Weston Aluminium Dross Recycling Facility Modifications 12 and 14

Weston Aluminium Emission Reconfiguration
State Significant Development Modification Assessment (DA
10397 of 1995 MOD 12 and DA 86-04-01 MOD 14)

September 2021

Published by the NSW Department of Planning, Industry and Environment

Figure 6 | Predicted Cadmium Emission Contours

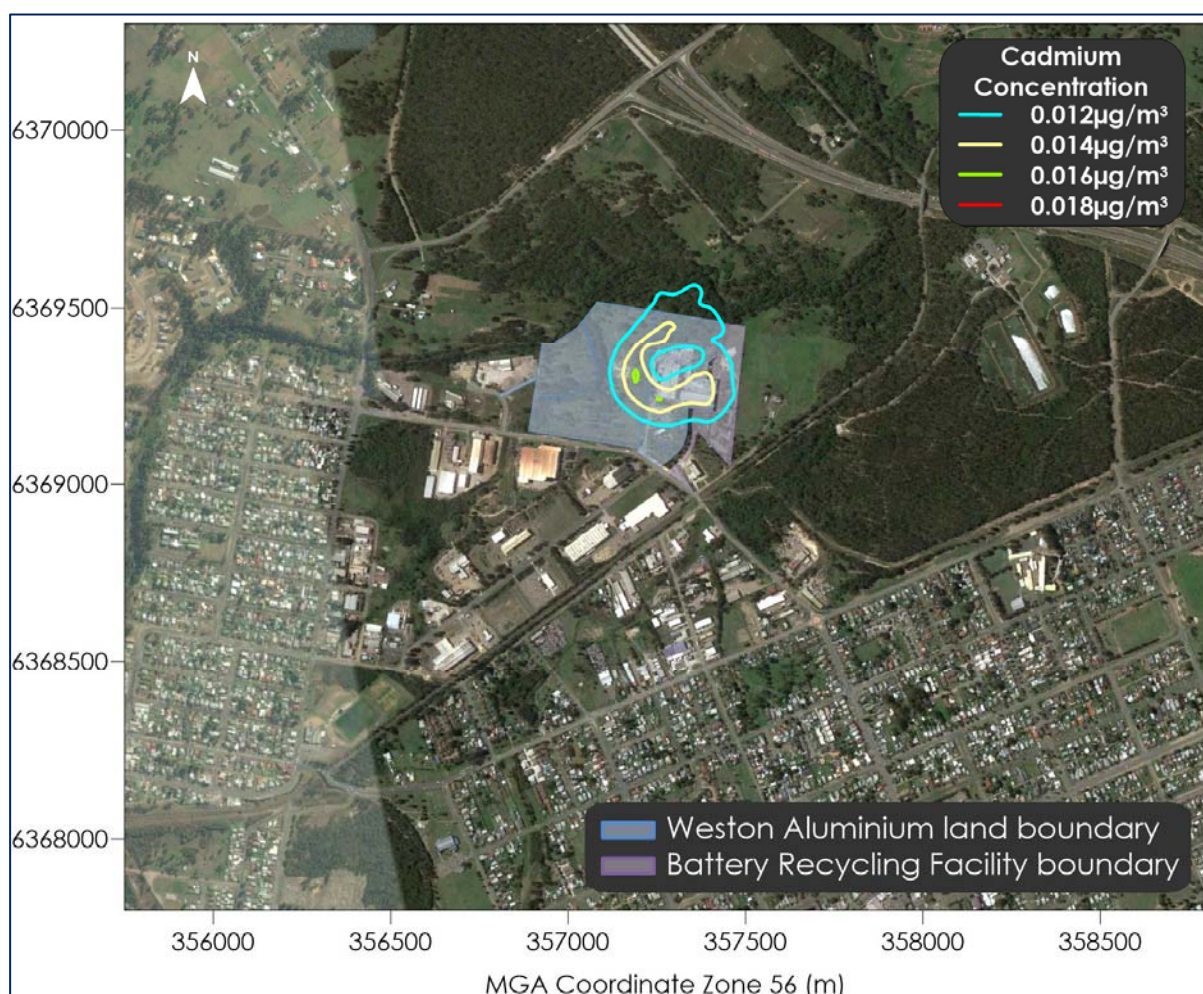
On review of the amended AQIA, the EPA advised it was inconsistent with the EPA's Approved Methods as:

- predicted impacts exceeded the criteria
- cadmium, which is a principal air toxic, had not been minimised to the maximum extent achievable through application of best-practice design or emission controls for the TWTP
- the use of A HHRA to assess impacts is inconsistent with section 7.3 of the Approved Methods.

The EPA suggested the Applicant propose a reduction of the licence limits for cadmium at the TWTP and remodel existing stacks at worst case monitored concentrations then undertake a reassessment based on the revised inputs. It would then be able to review licence limits where necessary.

In response, the Applicant advised it considered Stack 1 can meet lower limits due to the proposed upgrades. It therefore proposed alternative cadmium limits for both the TWTP (which is not a component of this modification) and Stack 1 and undertook revised modelling, using these lowered EPL limits (see Table 2), which demonstrated that the Scenario 2 (which is the most conservative scenario as all stacks have been modelled operating at their licence limits 24 hours a day seven days a week), would comply with the relevant ground level criteria for cadmium (see Figure 6).

Following review of the revised modelling, the EPA advised it was satisfied it could recommend conditions of consent based on the lowered cadmium limit. It also recommended the H₂SO₄ (sulfuric acid) air concentration limit be lowered for the same stacks, the Applicant did not raise any concerns with this proposal.
